Product Change Notification / CAAN-01YQNE233

CCB 5352 Initial Notice: Qualification of MMT as an additional assembly site for selected MCP990xx, EMC14xx and CAP12xx device families available in 10L VDFN (3x3x0.9mm) package.

PCN#: CAAN-01YQNE233

Pre and Post Change Summary

HANC/ATP7

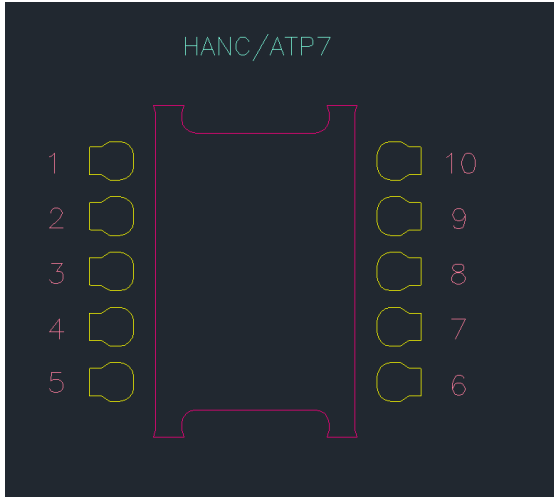
Assembly Site	HANC	ATP7
Lead Lock	No	No
Lead Plating	NiPdAu	NiPdAu
Lead-Frame Paddle Size	70 x 98 mils	71 x 98 mils

MMT

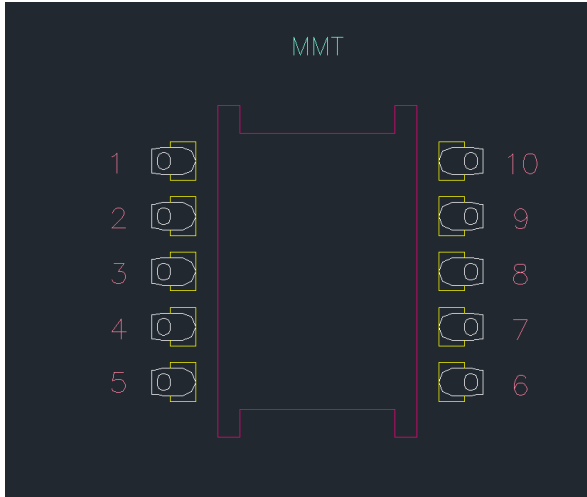
Lead Lock	Yes
Lead Plating	NiPdAu
Lead-Frame Paddle Size	71 x 98 mils

Note: The lead lock hole fills with mold compound during the assembly process and provides improved protection against moisture penetration around the interface edges between pins and mold compound.
